SBN- 318
T.F. B 7.1.2

References: (a) Construction Permit CPPR-135 and CPPR-136, Docket
Nos. 50-443 and 50-444
(b) USNRC Letter, dated July 27, 1982, "Request for Additional
Information", F. J. Miraglia to W. C. Tallman

Subject: Response to 410 Series RAIs; (Auxiliary Systems Branch)

FIGURE 32-1

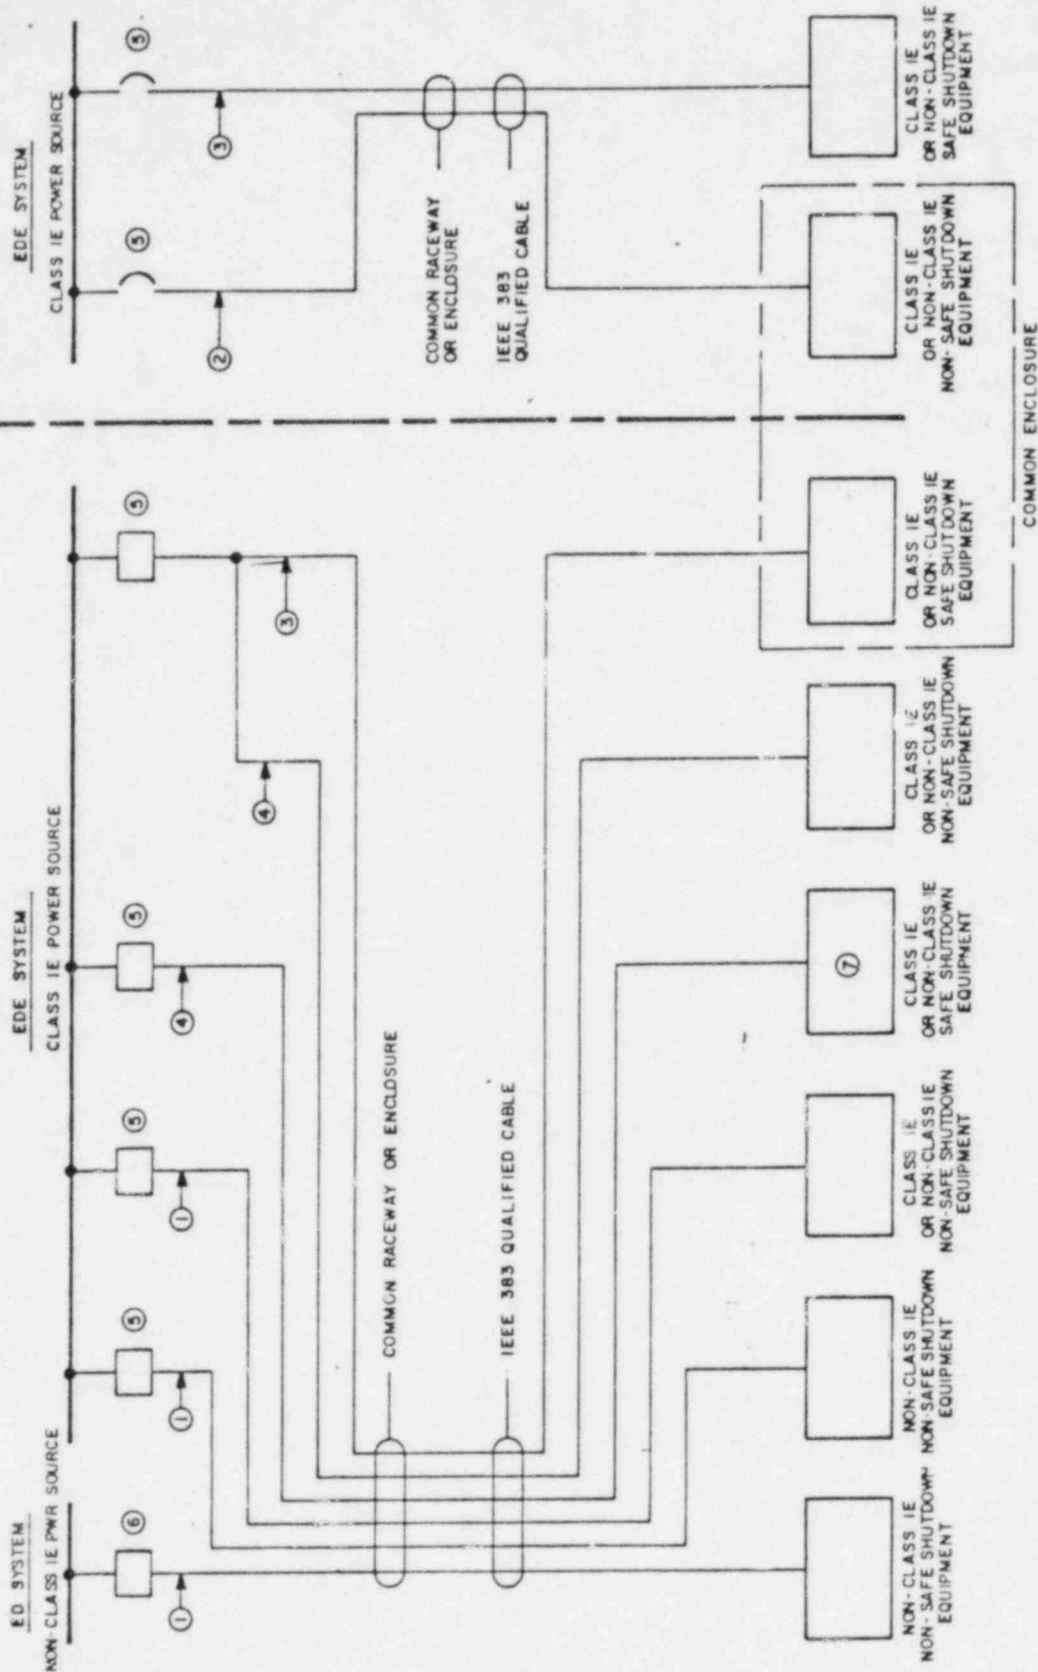
The applicant should address the means provided for assuring the function of the safe shutdown capability when considering fire induced failures in associated circuits. The enclosure provides the staff concern with associated circuits. The enclosure also provides guidance needed by the applicant to review associated circuits of concern and the information to be provided for staff evaluation. The applicant should address Part II.C of the enclosure.

Sections 3.2.2.1, 3.2.2.2 and 3.2.3.3 in conjunction with Figure 3.2-1 describes the methodology utilized to address the following types of associated circuits:

As stated in FSAR Section 8.3.1.4, all non-Class 1E circuits are associated with either Train A or Train B in accordance with the provisions of FSAR Appendix 8A Section 4.5a. Based on this design consideration, associated circuits can be powered from the Class 1E electrical distribution emergency (EDE) system or from the non-Class 1E electrical distribution (ED) system and further may be routed in the same raceways and terminate in the same enclosure as Class 1E circuits. Although all safe shutdown circuits are powered from the EDE system, not all safe shutdown circuits are considered to be Class 1E. There are no safe shutdown circuits powered from the ED system.

Associated circuits that are powered from the EDE system, and are associated with the safe shutdown circuits by a common power supply, are protected by a coordinated circuit breaker and, hence, are not considered to be associated circuits of concern.

The review of each system required to satisfy the Safe Shutdown functions included all valves necessary to operate the system or maintain the system process boundaries. This assures that the safe shutdown system will operate as designed. If valves or other equipment from one train (i.e., Train A) are required for operation or could prevent operation of the other train (i.e., Train B), then additional reviews are performed to determine the failure modes and provide manual actions or operations of other equipment that would prevent the spurious

The deleterious effects of fire on associated circuits in common enclosures is eliminated by the following three design considerations:

- a. Coordinated circuit breakers, fuses or similar devices will assure that the associated circuit failure does not prevent the redundant train from performing its safe shutdown function.
- b. The cables are qualified to IEEE Standard 383; hence, the propagation of the fire from one train to the redundant train in another fire area/zone is very unlikely.
- c. Train and channel separation for cable routing is assured by a computerized cable routing program which does not allow cables with different circuit code assignments to be routed in the same raceways.

Based on the above design considerations, associated circuits in common enclosures are not considered associated circuits of concern.
